Re: Natural Gas – PHMSA's Valve Study – ORNUTM-2012/411 ORNUTM-2012/411: Requirements of Automatic and Remotely Controlled Shutoff Valves on Hazardous Liquids and Natural Gas Pipelines with Respect to Public and Environmental Safety

Comments from the Interstate Natural Gas Association of America on Draft Research Report

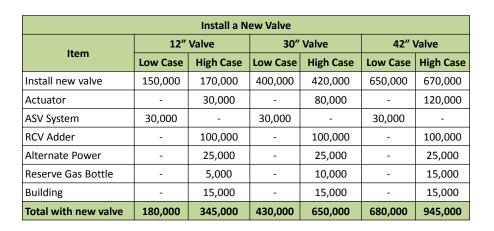
The cost saving due to earlier fire fighter access and their mitigation of the damage is under \$6 million in all the examples. While the damage percentage might be small to the operator, the loss of each house to the individual owner is catastrophic. This difference in perception needs to be addressed.

Therefore ORNL confirmed that advantage of faster valve operation and closer valve placement has almost no effect on the total damage estimate.
